NVM Express Workgroup c/o VTM, Inc. 3855 SW 153rd Drive Beaverton, OR 97003 USA info@nvmexpress.org **NVM Express® Technical Proposal (TP)**

Technical Proposal ID	TP 4130a Cross-Namespace Copy		
Revision Date	2024-02-26		
Builds on Specifications	NVM Express NVM Command Set Specification 1.0c NVM Express Base Specification 2.0c		
References	TP 4098a Multiple Atomicity TP 4141 Storage Tag Mask Enhancements

Technical Proposal Overview

Figure 136: PI Processing for Copy MD=8 Pass-throughProtection Information Processing for Copy

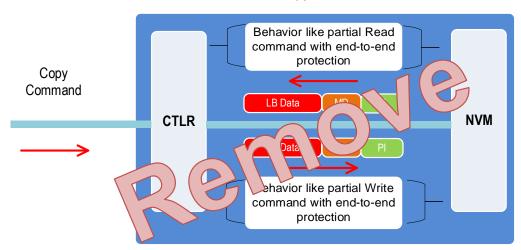
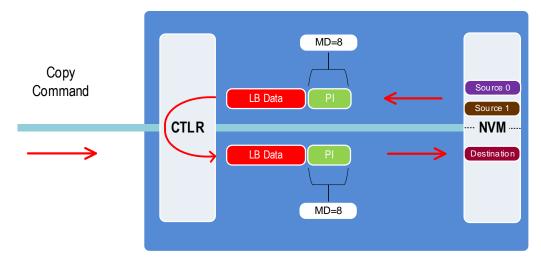
Protection Information with PRACT bit cleared to '0' (i.e., pass)

MD=8, PI, PRINFOR.PRACT=PRINFOW.PRACT=0: PI pass-through

Figure TBDda1: PI Processing for Copy MD=16 Pass-through

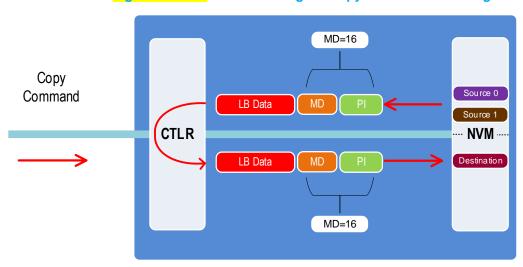
MD=16, PI, PRINFOR.PRACT=PRINFOW.PRACT=0 : PI pass-through

Figure TBDda2: PI Processing for Copy MD=8 Replace

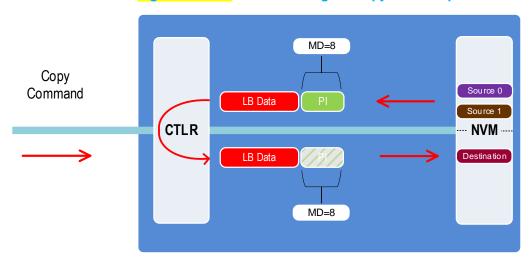
MD=8, PI, PRINFOR.PRACT=PRINFOW.PRACT=1: PI replace

- If the PRINFOR.PRACT bit and the PRINFOW.PRACT bit are both set to '1', then as the logical block data and metadata pass through the controller, the PI is replaced with PI that is generated by the controller as shown for the examples in Figure 136 and Figure TBDda1; and
- If the PRINFOR.PRACT bit and the PRINFOW.PRACT bit are both cleared to '0', then the logical block data and metadata pass through the controller without change to the PI as shown for the examples in Figure TBDda2 and Figure TBDda3.

Figure TBDda3: PI Processing for Copy MD=16 Replace

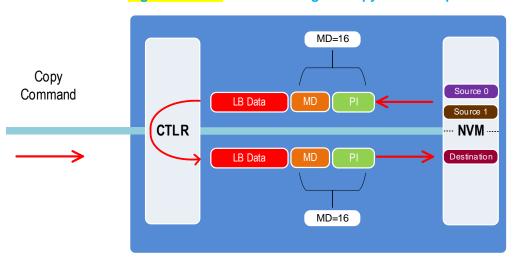
MD=16, PI, PRINFOR.PRACT=PRINFOW.PRACT=1: PI replace

Figure TBDda4: PI Processing for Copy MD=8 Insert

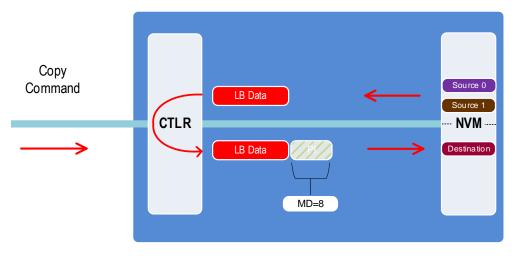
destination MD=8, PI, PRINFOW.PRACT=1: PI insert

then as the logical block data passes through the controller, the controller generates and appends PI to the end of the logical block data as shown for the example in Figure TBDda4. All other cases in which the destination namespace is formatted with PI and a source namespace is formatted without PI result in the controller aborting the Copy command with an error status (refer to section 3.2.2.STBD4.2), including cases where the metadata size of the destination namespace is larger than the PI size of that namespace.

Figure TBDda5: PI Processing for Copy MD=8 Strip

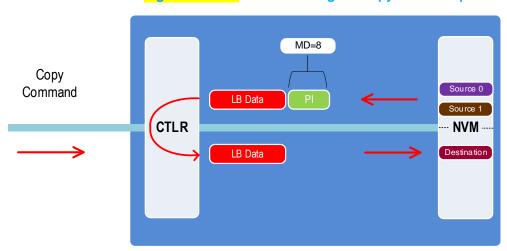
source MD=8, PI, PRINFOR.PRACT=1: PI strip

then as the logical block data and metadata pass through the controller, the PI is stripped, and the controller only writes the logical block data to the NVM as shown for the example in Figure TBDda5. All other cases in which the destination namespace is formatted without PI and a source namespace is formatted with PI result in the controller aborting the Copy command with an error status (refer to section 3.2.2.STBD4.2), including cases where the metadata size of a source namespace is larger than the PI size of that namespace.
